**STATE OF NEW MEXICO
VILLAGE OF TAOS SKI VALLEY**

RESOLUTION NO. 2019-389

AGENDA ITEM TITLE: Discussion and Consideration to Approve a Change Order to the RMCI Contract for Not-to-Exceed \$250,000 in the Construction of the Kachina Water Tank project.

KACHINA WATER TANK COST SAVING ALTERNATIVES

RAISING THE CONCRETE TANK ELEVATION

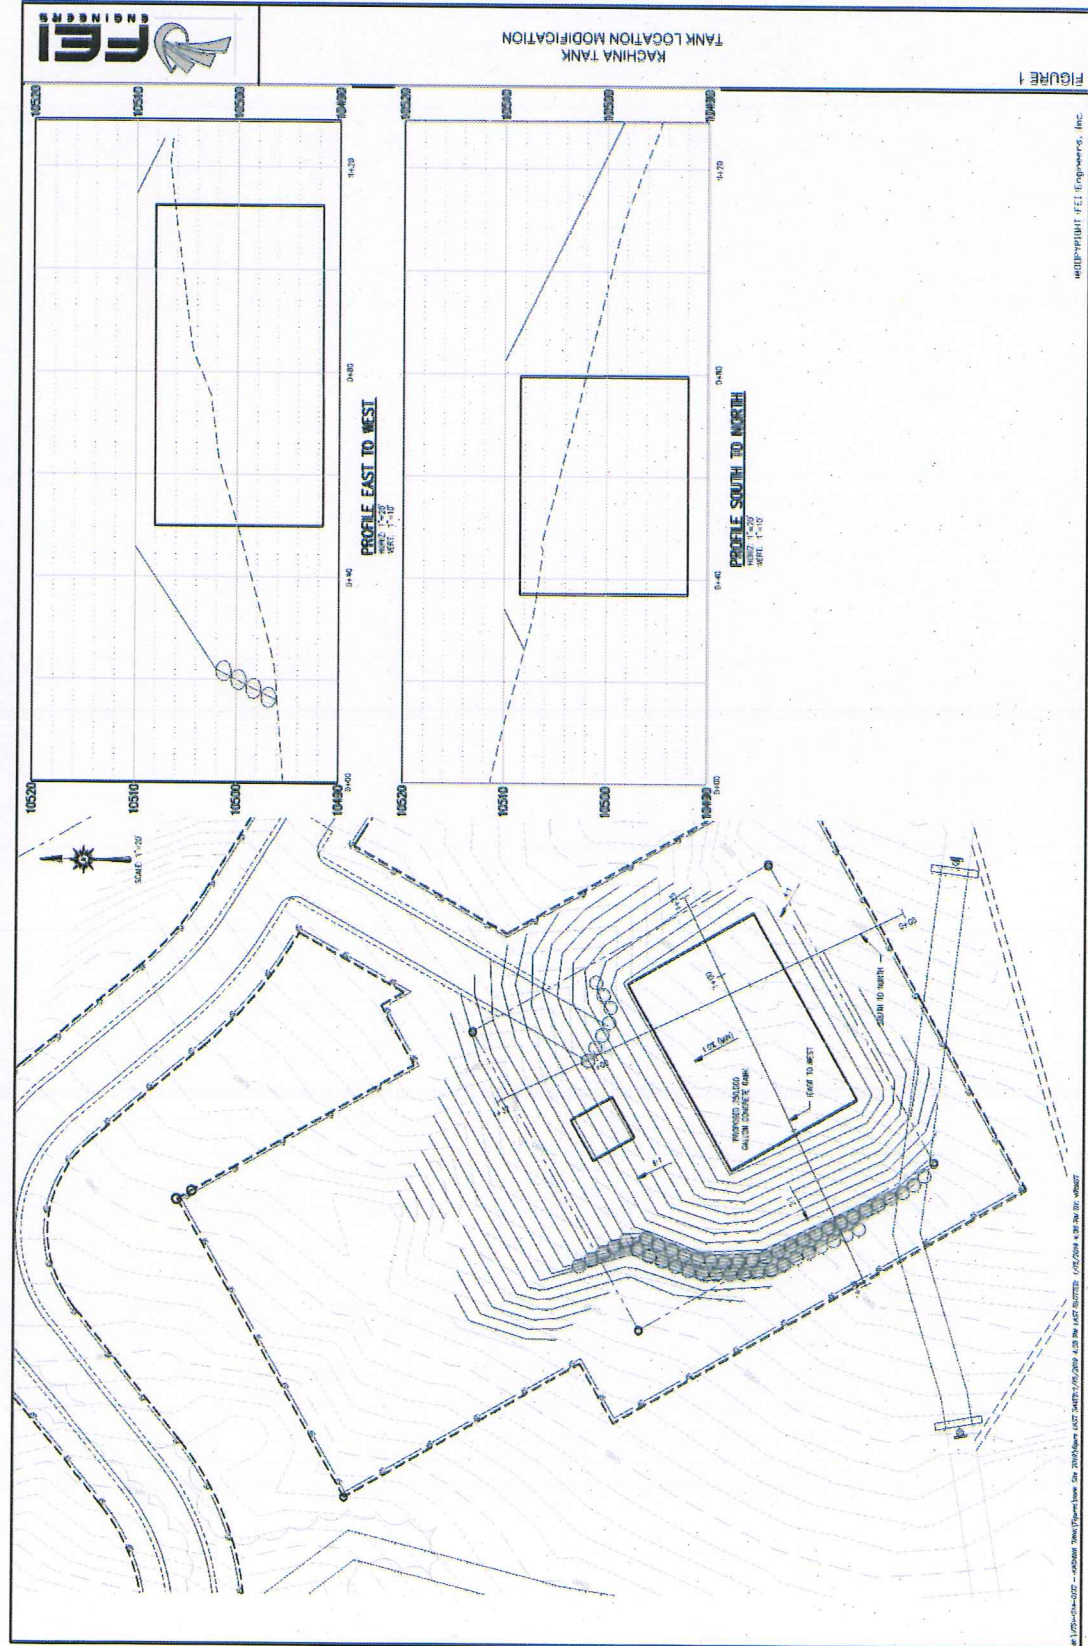
- **Concrete Tank Alternatives**
 - Option 1: Current Design Buried
 - Option 2: Redesign Raised and Buried
 - Option 3: Redesign Raised and Partially Buried

Option 1 (Current Design) – Fully Buried		
	Advantage	Disadvantage
Function & Design	- Fully buried helps minimize freezing - Design is complete	- Requires a significant amount of excavation (e.g. 20-ft below native grade in some areas) - Requires most material export
Cost	Site "balances"	CO#3 \$240,000
Aesthetics	Fully buried will allow for site grading to revegetate

Advantage	Disadvantage
Function & Design	o Burial helps minimize freezing	- o Re-design required - o Steeper slopes on sides of tank make access more challenging - o Requires most material import
Cost		- o CO #3 \$330,000 - o Most expensive capital cost
Aesthetics	o Fully buried	- o Use rock slopes (to minimize scree or talis fields) - o Limited revegetation

Advantage	Disadvantage
Function & Design	Partial burial and snow cover in the winter will help protect against freezing, along with mixers	- Re-design required - Additional opportunities for vandalism (all hatches locked, but no fencing) - Still required material import
Cost	\$40,000 construction cost savings	CO #3 \$210,000
Aesthetics		62.5-ft x 42.5-ft (2656-sf) concrete tank would stick up approximately 6-ft higher than surrounding grade

- For the Concrete Tank, Option 3 Raise and Partially Buried could save capital (construction costs)
- However, redesign is required, aesthetics are a concern, and TSVI may try to delay the project again
- A steel tank would likely reduce capital (construction costs), however, the life cycle costs are higher. Avalanche, aesthetics, freezing, and vandalism are also concerns
- Proceed with the current design

PROS & CONS OF STEEL

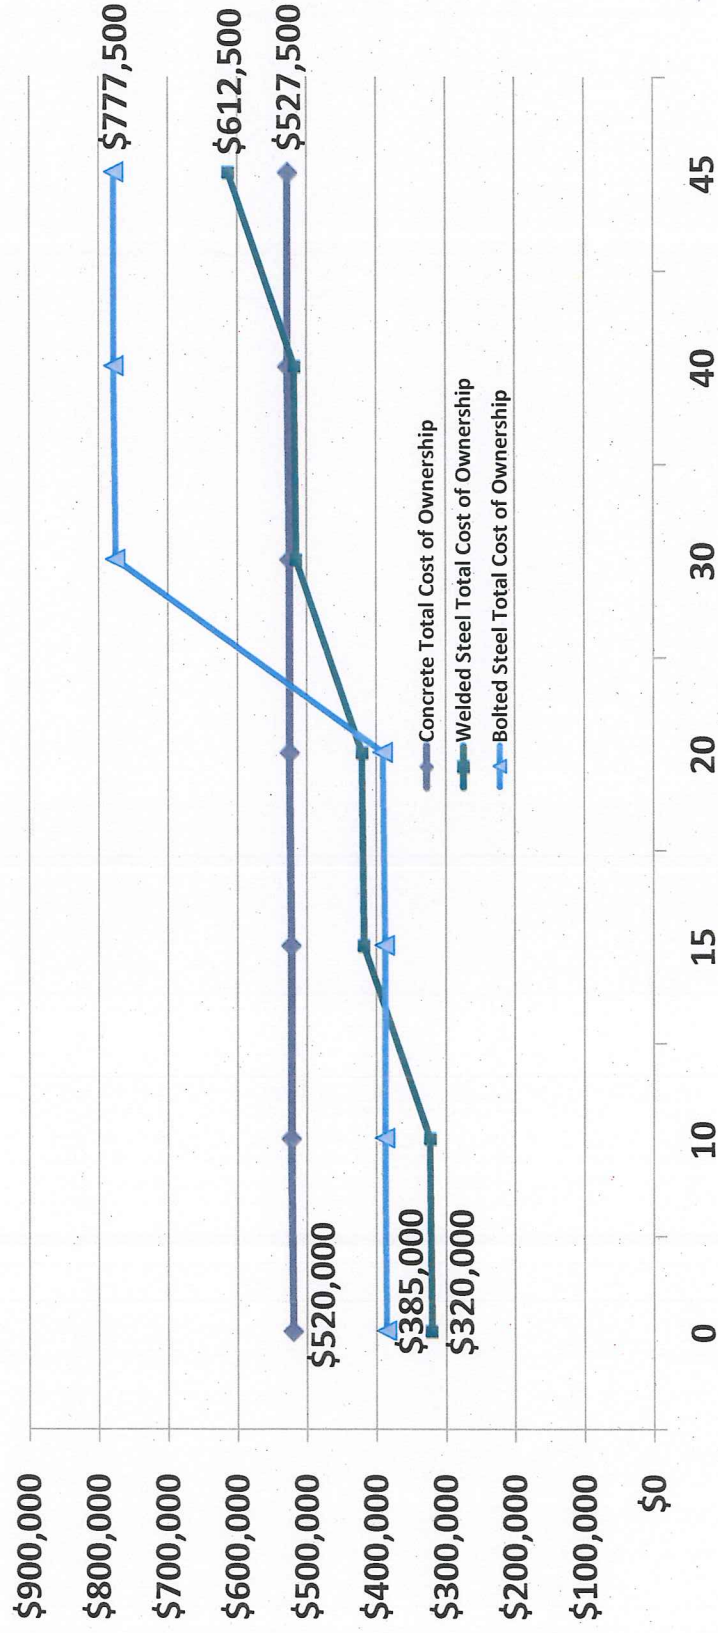
Advantage	Disadvantage
Design	- Material: Carbon Steel - Paint: Welded is Field Applied Epoxy/Urethane and Bolted is Factory Glass Fused to Steel - Roof: Aluminum Geodesic Dome - Foundation Concrete Ring Footer or Piers (TBD)	- Re-design required - Typically fully above grade (allows for maintenance) 44' diameter x 24' high or 50' diameter x 16' high or 72' diameter x 8-1/2' high - Cathodic protection may be needed - More subject to freezing (above grade)
Longevity, Safety, and Security	- Welded steel can have comparable life, if maintained properly - Glass fused to steel does not require maintenance, but has shorter life 25-40 years	- Steel less likely to withstand possible impact from nearby avalanche shoot - More susceptible to vandalism such as gunshots
Additional Considerations	- Possibly less expensive capital costs - Shorter construction/erection once the site is prepped	- Longer water age (inability to create two chambers) - May be required to re-bid project - Contract may not be ready by start of 2019 construction season (risk of losing funding and/or easement)

Costs	Less expensive capital (construction) cost	More expensive capital (construction) cost
